ADDENDUM#	Date	No
1	12/4/09	1
Revision

MAINE MEDICAL CENTER
 PAVILION 6 RENOVATIONS
 MorrisSwitzer Project Number 28034
 Date 11/19/09
 Scale 1/8" = 1'-0"
 Sheet Title and Number
SECOND FLOOR
PAVILION "C" & "D"
INTERIM OCCUPANCY
FIRE PROTECTION PLAN
2FP1.0

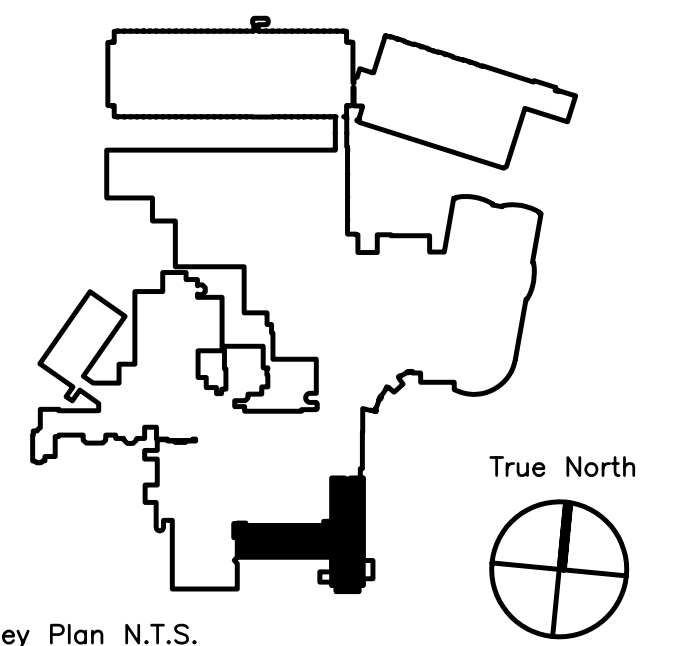
FIRE PROTECTION WORK NOTES:
 1 REMOVE EXISTING SPRINKLERS AND REPLACE WITH INSTITUTIONAL TYPE SPRINKLERS.
